Proposed Modifications to Previously Approved Scheme Reg. Ref SD20A/0283

Project Title: DUB 14/15
Proposed Modifications to Previously Approved Scheme SDA\0283

Drawing Title: Overall Site Plan
Proposed

1 Overall Site Plan - Proposed
1 : 1000

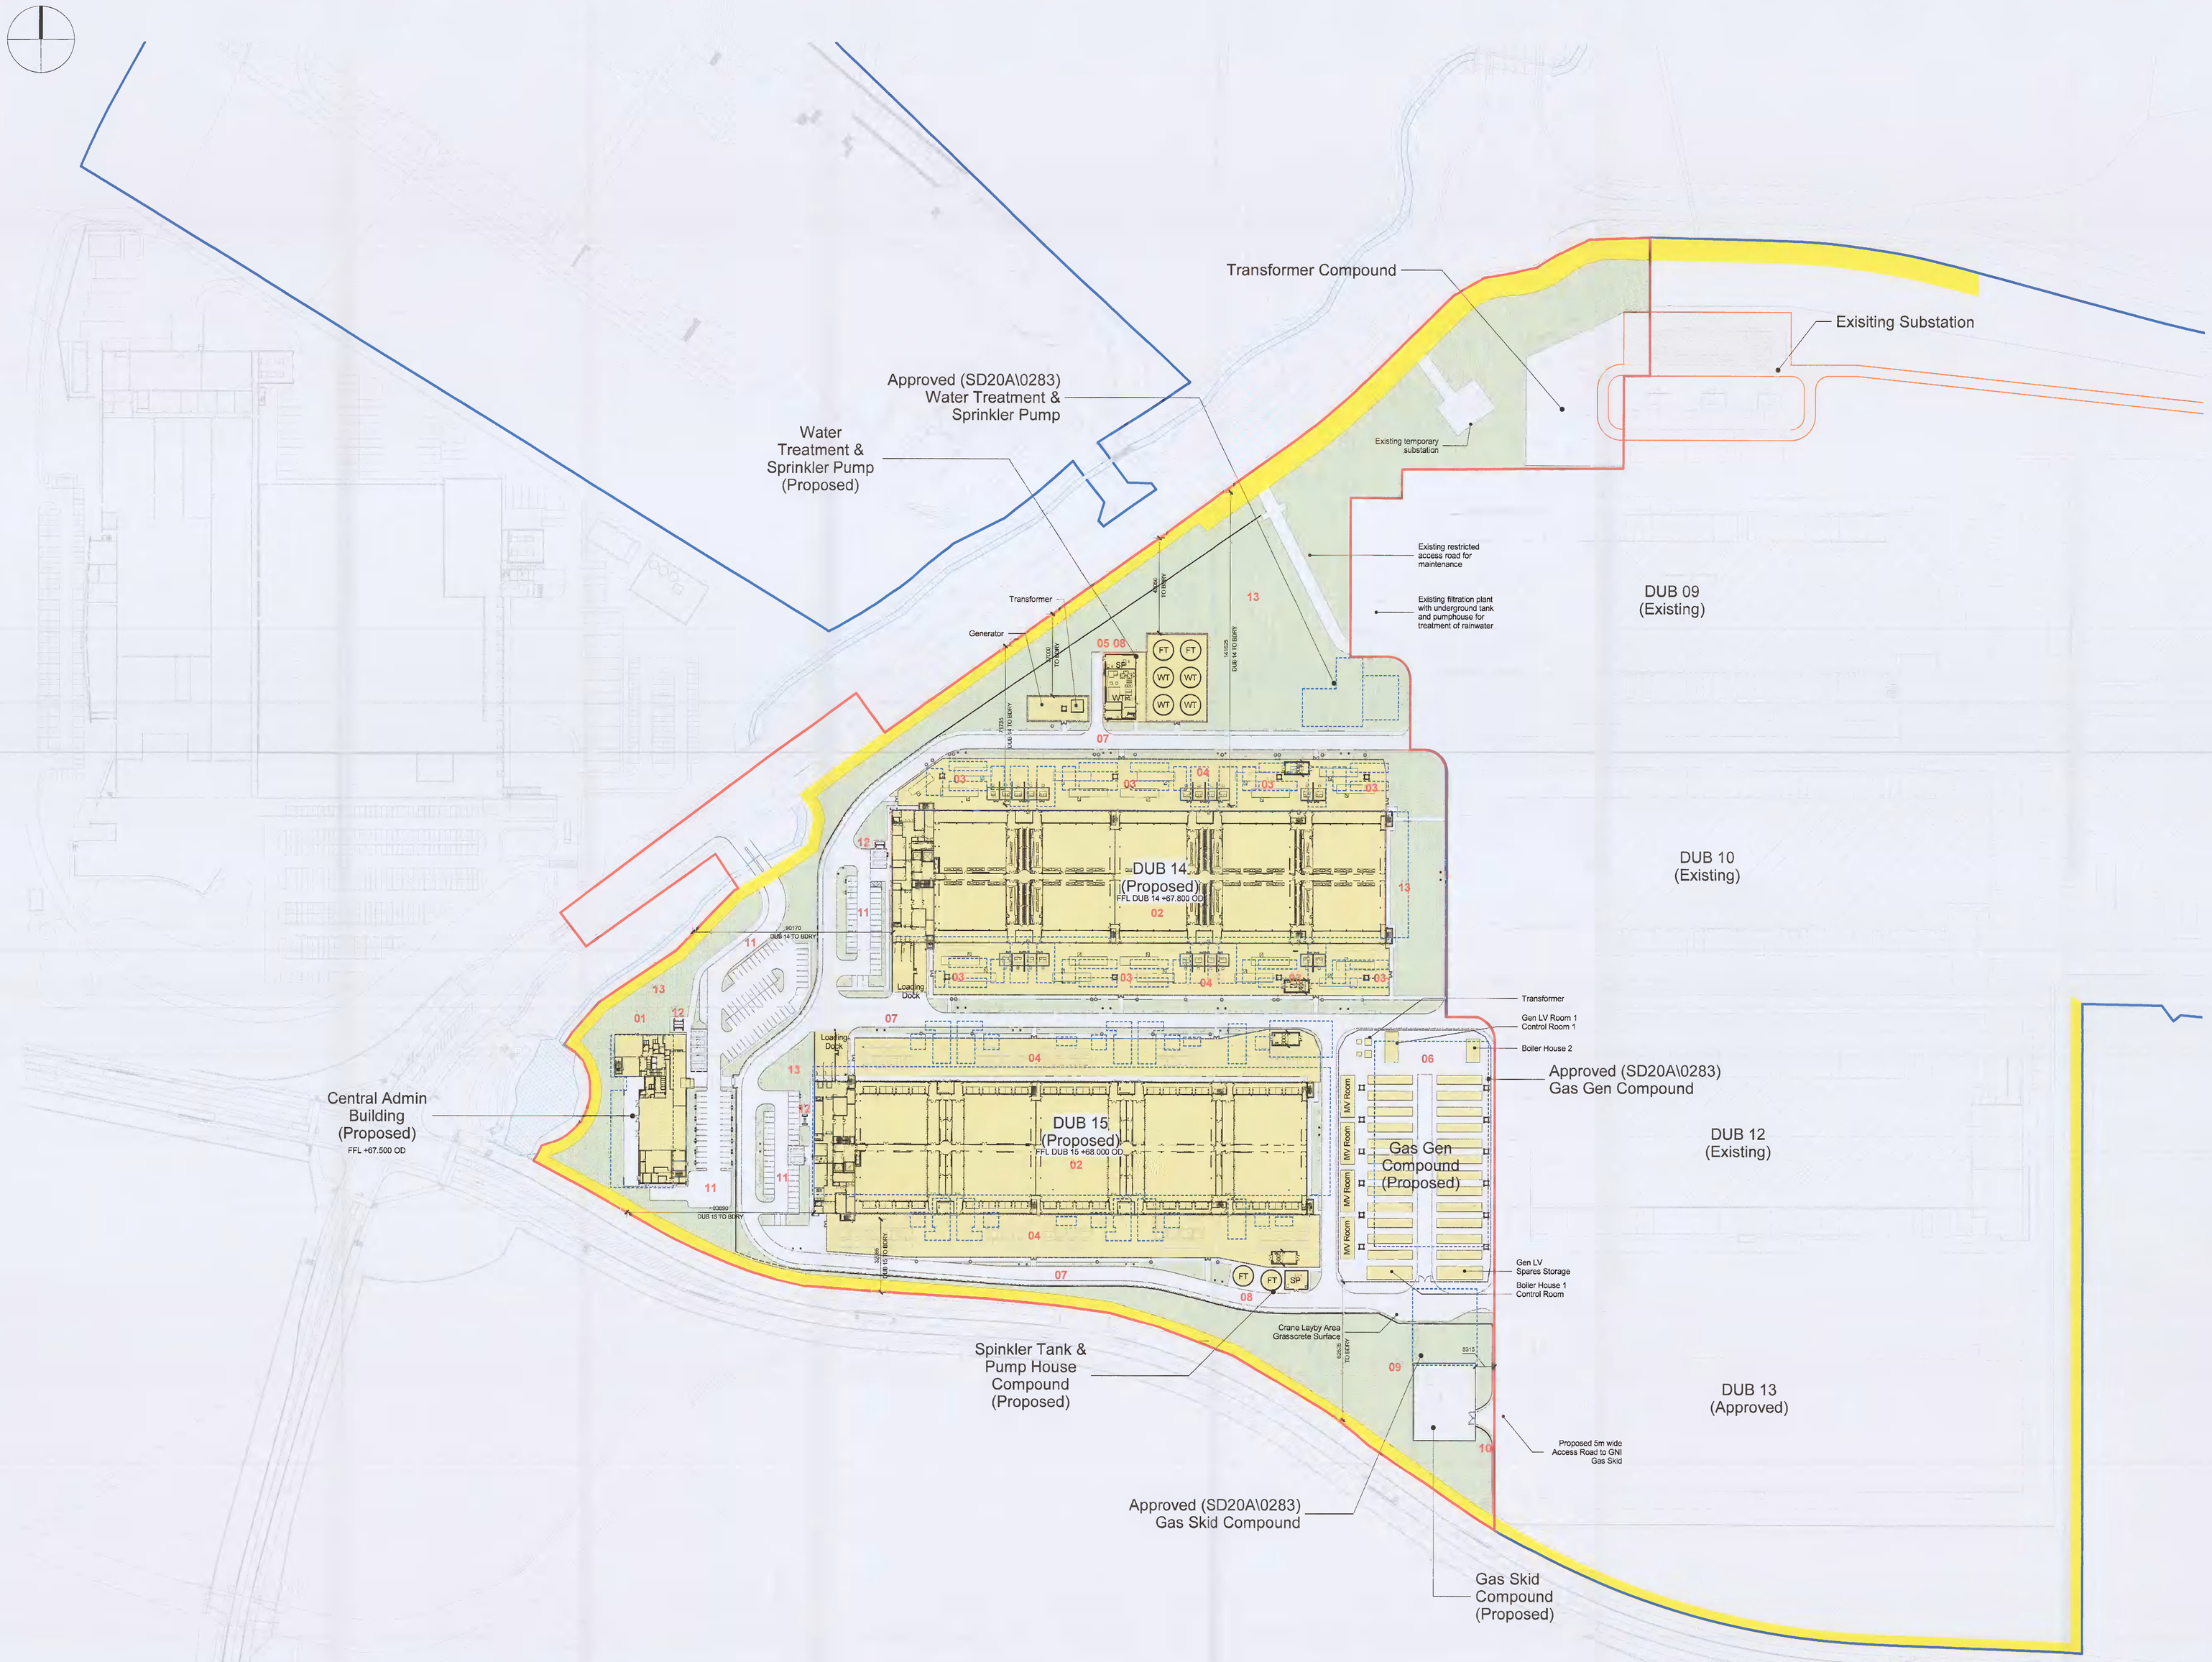
Proposed reconfiguration and revised setting out of previously approved building plans and associated changes to elevations, reconfiguration of and minor additions to miscellaneous plant and changes to hard & soft landscaping layout.

1 1.Approved Central Administration Building (CAB):
a. Building moved to the east by approx. 7m.
b. Increase of building footprint by approx. 170m2 (from 1.424m2 to 1.594m2)
c. Design development - changes to building layouts & elevations (design and finishes).
d. Approved four-storey Office element: Parapet at roof level to be raised by approx. 1.85m.

2 2.Approved Data Centres – DUB14 and DUB15:
a. Reconfiguration of building footprints & reduction in area of approx. 48m2
b. Design development - changes to building layouts & elevations (design and finishes)
c. Omission of zone of sedum roof finish.

3 DUB 14: Reduction in height of approved flues by approx. 650mm.

4 Reconfiguration of associated external plant at ground level (including generators / E-Houses & transformers) flues, modification to design of screening to generator yards, omission of approved Modular Electrical Rooms (MERs) serving approved Data Centres DUB14 &15.

5 Relocation, modifications to design and expansion of approved Water Treatment Building and associated plant.

6 Gas Generator Compound – Relocation & reconfiguration of previously approved gas generator compound including an additional flue.

7 Modifications to approved layout of internal site roads, yards and footpaths.

8 Relocation and modifications to design of approved Sprinkler Tanks and Pump House.

9 Relocation of Approved Gas Networks Ireland (GNI) gas skid & compound including approved 3 no. kiosk buildings.

10 Proposed new vehicular access to serve revised GNI location off the existing Data Centre Compound.

11 Modifications to approved car park layouts and landscaping design

12 Modifications to location and design of approved bicycle shelters.

13 Modifications to site development works, including underground water and building services provision, landscaping, Internal security and compound enclosure fencing, and associated works.
